AGENDA
HAILEY PLANNING & ZONING COMMISSION
Monday, October 5, 2020
Virtual Meeting
5:30 p.m.

PH 1 Consideration of a Design Review application by Jason Szabo and Chris Wrede, for a new two story, 1,750 square foot residence called the Bungalow, to be located at Lot 9A, Block 49, Hailey Townsite (TBD N 4th Ave) in the Limited Residential (LR 1) and Townsite Overlay (TO) Zoning Districts. **ACTION ITEM.**

PH 2 Consideration of a Design Review application by Jason Szabo and Chris Wrede, for a new two story, 1,750 square foot residence called the Farmhouse, to be located at Lot 11A, Block 49, Hailey Townsite (TBD N 4th Ave) in the Limited Residential (LR 1) and Townsite Overlay (TO) Zoning Districts. **ACTION ITEM.**

To: Hailey Planning and Zoning Commission

SITE PLAN & PROJECT INFORMATION

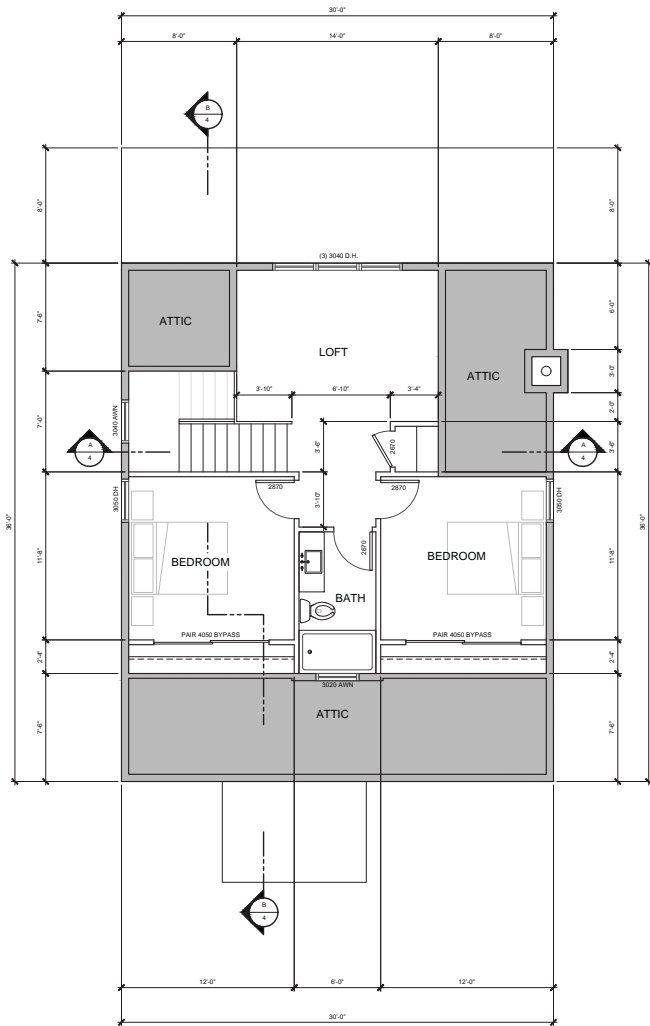
Staff Comments	<i>The site plan proposes approximately 784 square feet of hardscape (parking, vehicle and pedestrian areas). 25% of this (196 square feet) is required for snow storage. 200 square feet of snow storage is shown.</i>
<input checked="" type="checkbox"/>	<input type="checkbox"/>	<input type="checkbox"/>	17.06.090(C)7	Guideline: A snow storage plan shall be developed for every project showing: <ul style="list-style-type: none"> • Where snow is stored, key pedestrian routes and clear vision triangles. • Consideration given to the impacts on adjacent properties when planning snow storage areas.
			Staff Comments	<i>Snow storage areas are located to the rear of the proposed residence. Snow storage areas do not restrict pedestrian access. Pedestrian access is unrestricted and visible.</i>
<input checked="" type="checkbox"/>	<input type="checkbox"/>	<input type="checkbox"/>	17.06.090(C)8	8. Existing Mature Trees and Landscaping

NORTH EAST

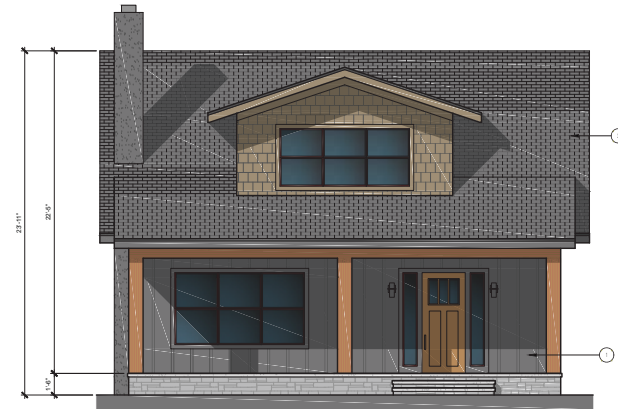
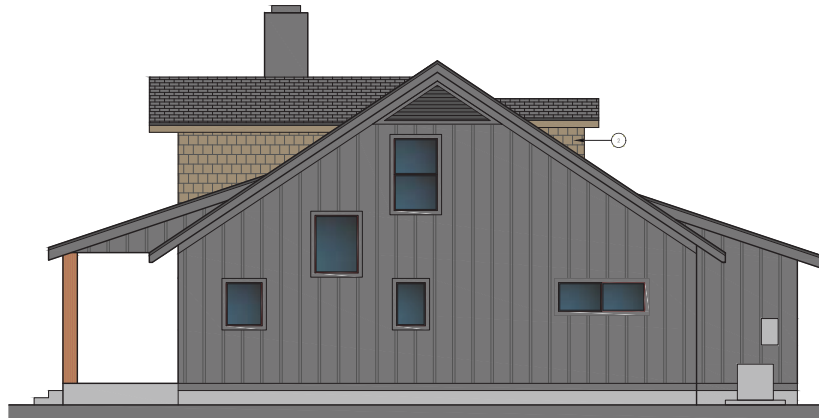
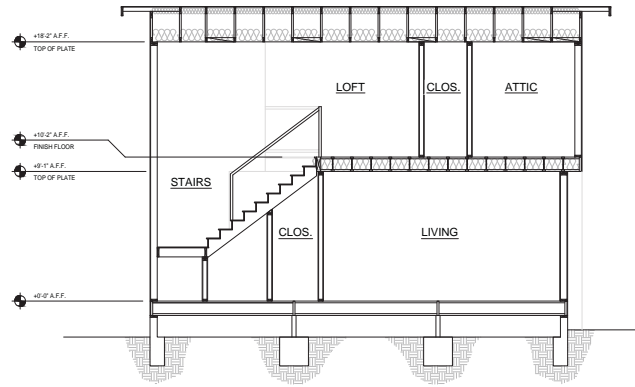
<p>NORTH EAST</p>
<input checked="" type="checkbox"/>	<input type="checkbox"/>	<input type="checkbox"/>	17.06.090(C)3h	<p>Guideline: Large wall planes shall incorporate more than one material or color to break up the mass of the wall plane.</p> <p><i>Staff Comments</i> The largest wall plane is the southeast elevation. This plane is broken up by a variety of window sizes, exterior chimney, and two exterior doors. Vertical siding and Hardie Shingles will help reduce the mass of said wall planes (see image below for further detail).</p>  <p>SOUTHEAST</p>
<input checked="" type="checkbox"/>	<input type="checkbox"/>	<input type="checkbox"/>	17.06.090(C)3i	<p>i. Ornamentation and Architectural Detailing</p> <p>Guideline: Architectural detailing shall be incorporated into the front wall plane of buildings.</p> <p><i>Staff Comments</i> Simple detailing is proposed: covered front entry and porch, beams, vertical and shingle siding.</p>
